REVIEW OF THE LAYOUT OF THE CONTAINER PIER IN
HALIFAX HARBOUR - APRIL 1969

AOL REPORT 1971-1

At the request of the National Harbours Board, the latest design of the proposed container pier at the Ocean Terminals (see Fig. 6) in Halifax Harbour has been reviewed and evaluated in terms of the probabilities of occurrence of significant swell action at the pier face.

Fig. 1. Layout of Pier "C".

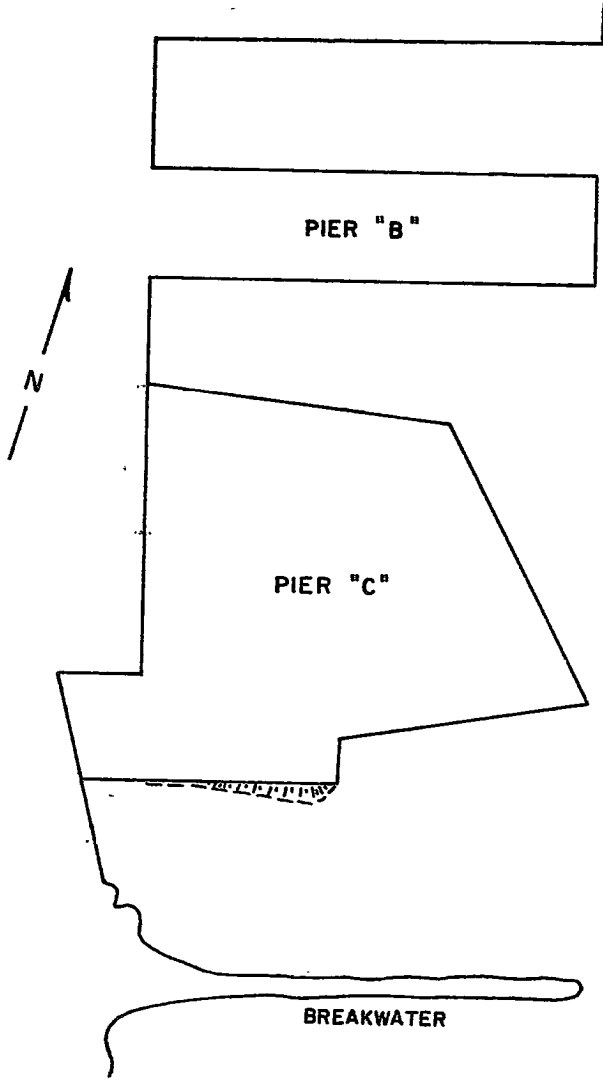
The original design of Pier "C" proposed by the National Harbours Board is shown in Fig. 1. Since it was anticipated at this stage that the new pier would handle mainly general cargo, the terms of reference were for improvements to this type of trans-shipment facility.

The most important conclusions with respect to the design of Pier "C" were:

- 1) Ocean waves which cause moored ships to oscillate spread in arc-shaped curves over the harbour so that their crests pass the Ocean Terminals at an angle somewhat less than 90 degrees. This is shown on the refraction diagrams of Fig. 2 and 3.
- 2) As demonstrated in the report, wharves should be located so that they are nearly normal to the wave crests. To follow this principle the major wharves of Pier "C" would have to be located not normal but parallel to the coast.
- 3) Waves reflecting from Pier "B" propagate into the area adjacent to Pier "C", where they are superimposed on the incoming waves, thus providing large energy concentrations in the area of interest (Fig. 4).

Several proposals which took these aspects into consideration were submitted. They included two breakwaters at the entrance to Halifax Harbour and a number of modifications to the original design of Pier "C". The former would provide improved protection for the entire harbour, while the latter would result in improving wave conditions only at Pier "C". On July 10, 1968 a

Fig. 6. Layout of Container Pier.

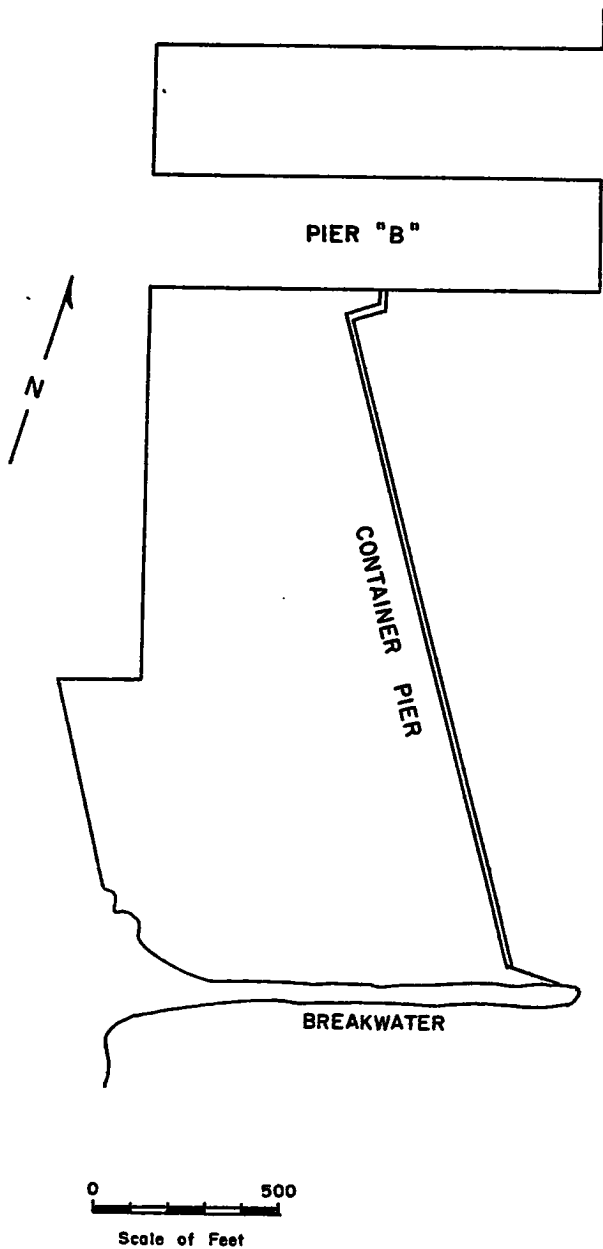
To keep Halifax Harbour competitive in the field of transportation, the National Harbours Board decided to modify Pier "C" to a container pier. The new design, Fig. 6, was released in March 1969 and the Bedford Institute was asked to review it with respect to wave action and its possible interference with loading operations. In addition, the question was asked as to whether an extension to the Point Pleasant Park Breakwater would provide sufficient protection for container loading.

The container pier is designed that its outer wall intersects Pier "B" halfway along its south wall. This arrangement creates problems which are difficult to solve. To demonstrate this, refraction diagrams of waves with periods of 6 seconds, 10 seconds, and 14 seconds, were plotted for the area adjacent to the container pier, as shown in Fig. 7, 8, and 9, respectively. The shapes of the initial wave fronts were derived from AOL Report 1968-3.

Thus, it must be assumed that the container pier in its proposed form would be unsuitable for container loading during a considerable number of days annually because of the relatively large amount of wave action in the area adjacent to the pier, and by the reflection of waves from Pier "B" which would cause an energy concentration at the container pier.

The disturbance caused by the reflected waves could largely be prevented by moving the wall of the container pier eastward until it is in line with the ends of Point Pleasant Park Breakwater and Pier "B". This arrangement would then be comparable with that of the sea wall, although the wave energy would be approximately double and the ship motion, therefore, greater.

Protection against the energy of the initial ocean waves can be provided only by breakwaters. As stated previously, an extension to the Point Pleasant Park Breakwater of about 700 feet would provide a considerable improvement in the wave conditions at the container pier; however, the improvement would be only local and of little benefit to the harbour as a whole. As demonstrated in AOL Report 1968-3 and shown in Fig. 10, breakwaters of comparable size, placed at the entrance to the harbour, should provide protection to the entire harbour, including the container pier.

Fig. 7. Wave refraction diagram of a 6-second wave train at the Container Pier.

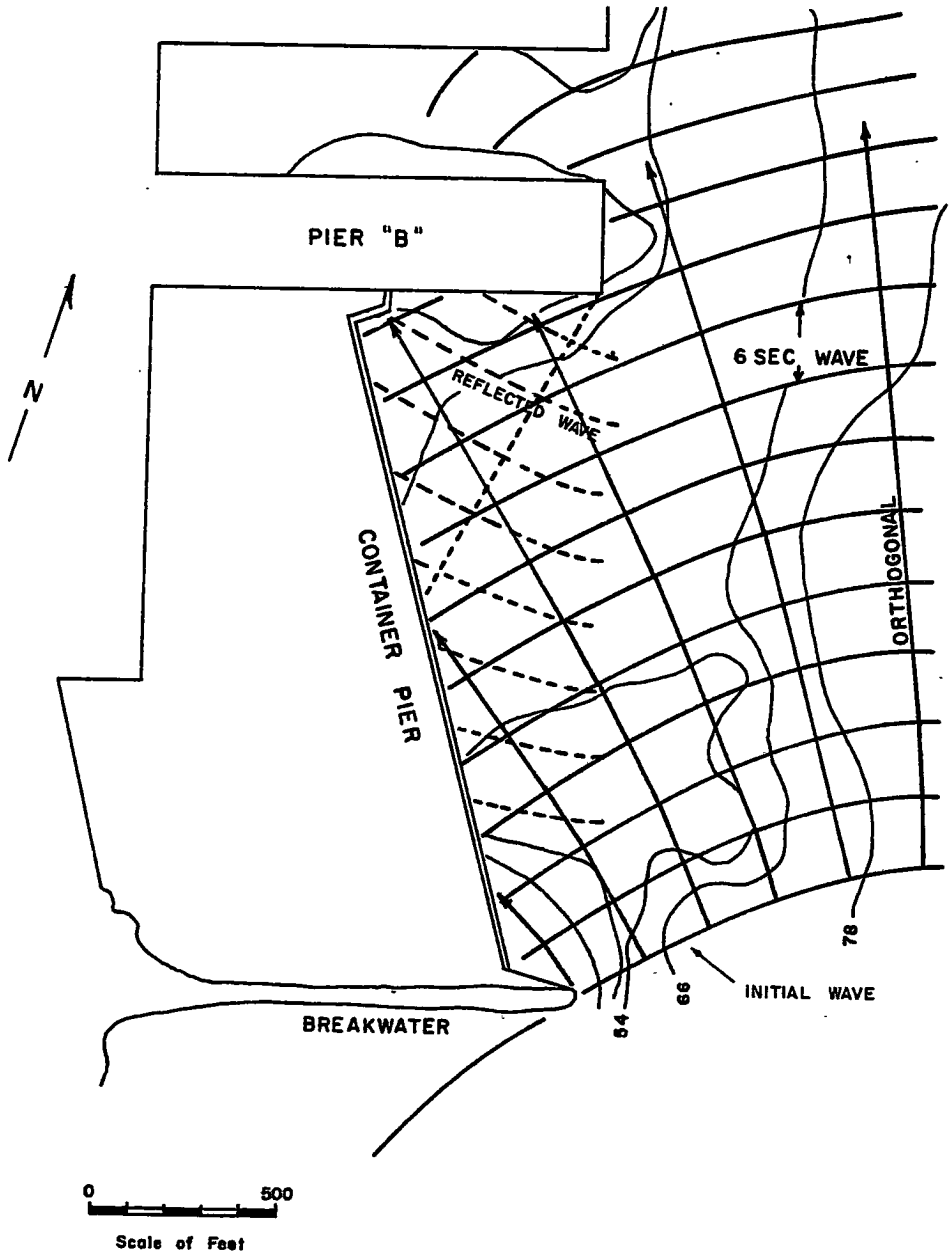
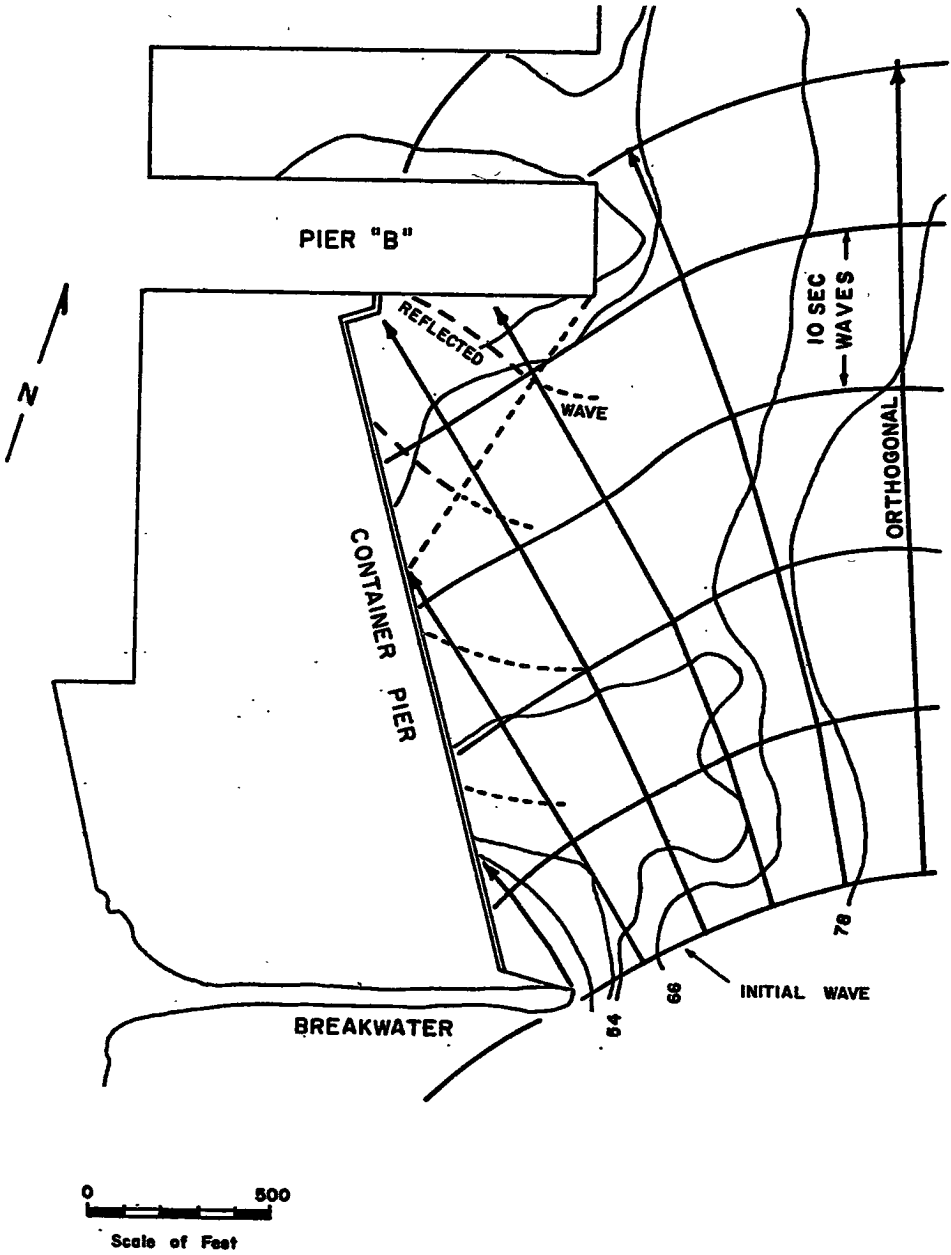
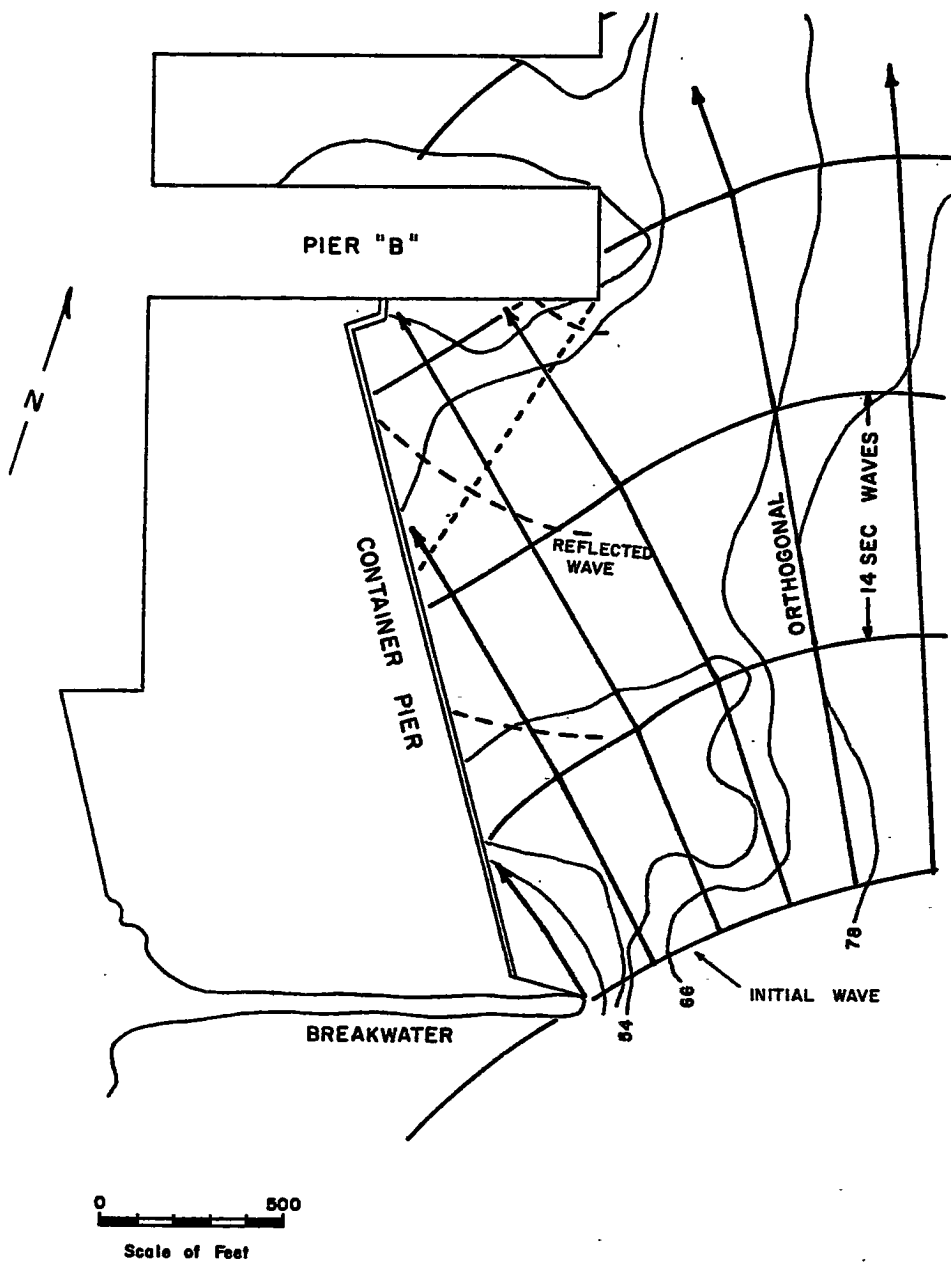
From the distribution of the wave fronts and the direction of the orthogonals, it can be seen that the shallower section east of Point Pleasant Park Breakwater directs the energy of the waves of all three periods toward the container pier and Pier "B". The orthogonals, which are spaced at 200-foot intervals, indicate that the energy which affects the area is derived from a front 700 feet wide, off the end of Point Pleasant Park Breakwater. Approximately half of this energy propagates toward the container pier and the other half towards Pier "B". The part which strikes Pier "B" is reflected toward the container pier, where it is superimposed on the initial wave, causing wave heights of appreciable magnitudes. It is probable, therefore, that with the proposed arrangement disturbances from waves will be several times more severe at the container pier than along the sea wall.

Fig. 10. Proposed breakwaters at the harbour entrance.

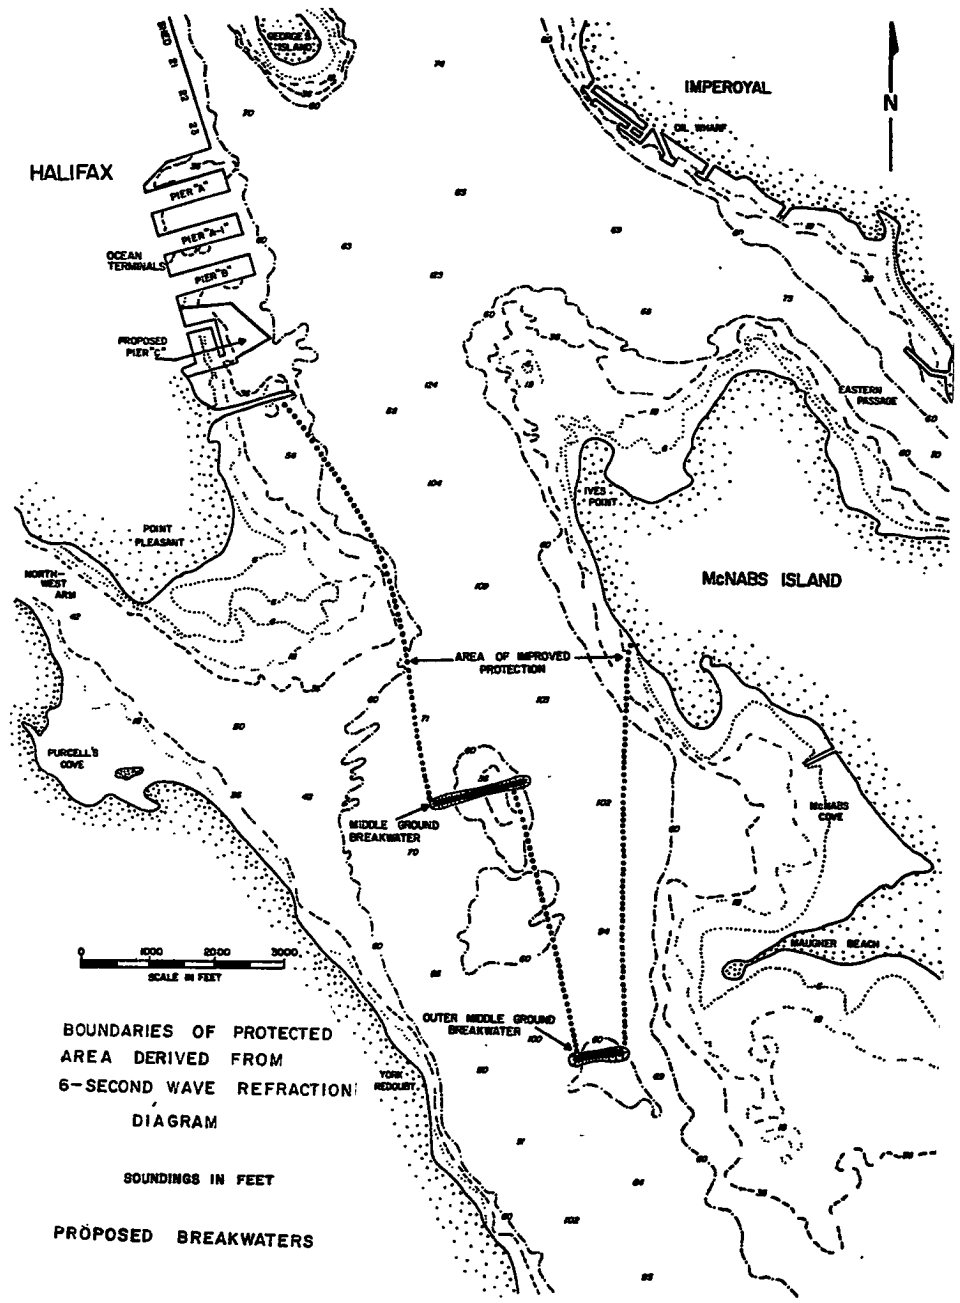
- 5) In the light of these conclusions, it would be advisable to consider other improvements, such as breakwaters at the entrance to the harbour.

Fig. 11. Proposed alternative layout of Container Pier.

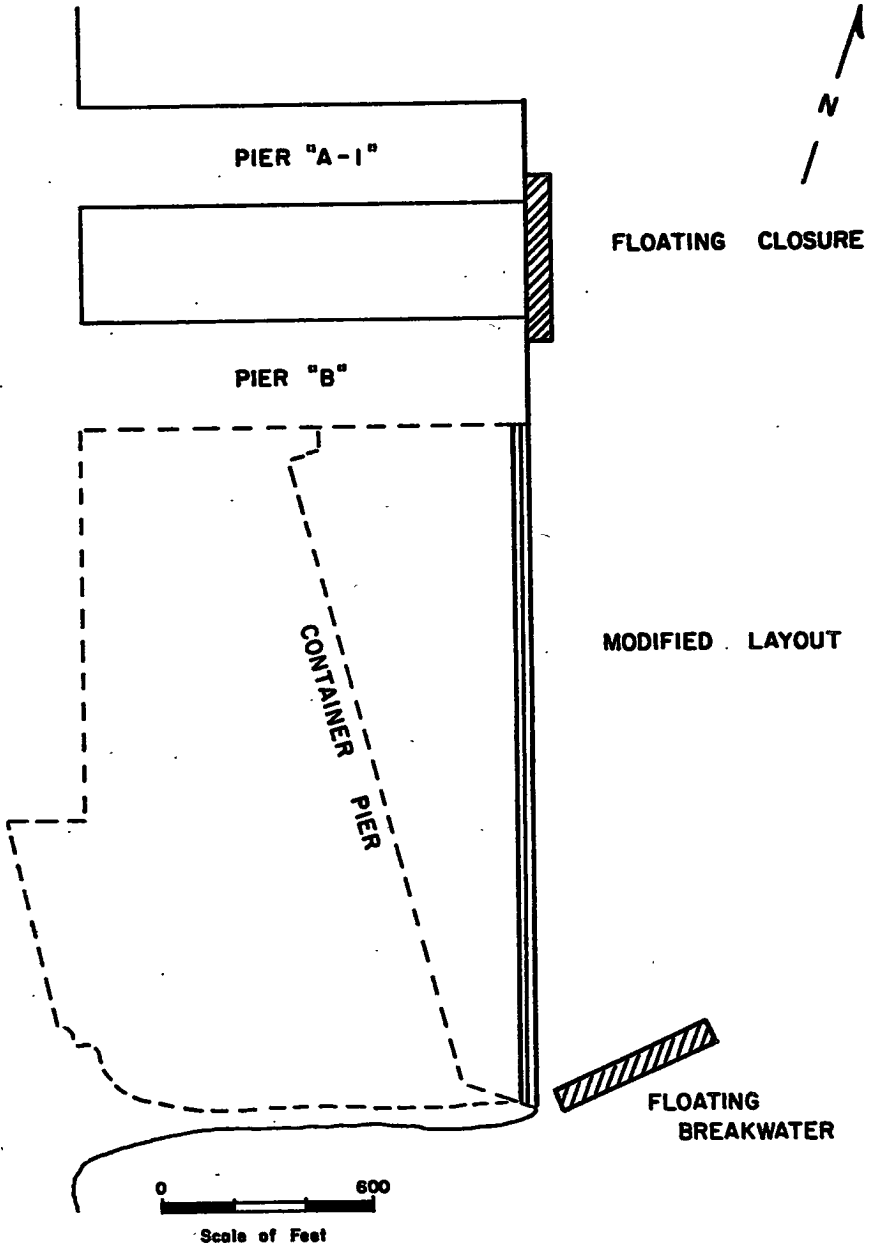
However, this concept could still be implemented by including Pier "B" and the adjacent basin in the container loading area, as shown in Fig. 11. Container ships, which are rigidly scheduled, would be berthed and loaded in the basin between Pier "B", which would be part of the container pier, and Pier "A-1". A floating structure would close the basin and reflect the waves so that only a negligible part of their energy could enter the dock. A laid-up vessel, a large barge or a specially-built floating concrete structure, might be used as a closure. For most of the year, when the ships are undisturbed by waves, the basin would remain open and the mobile closure could be moored off Point Pleasant Park Breakwater as an extension to the breakwater.
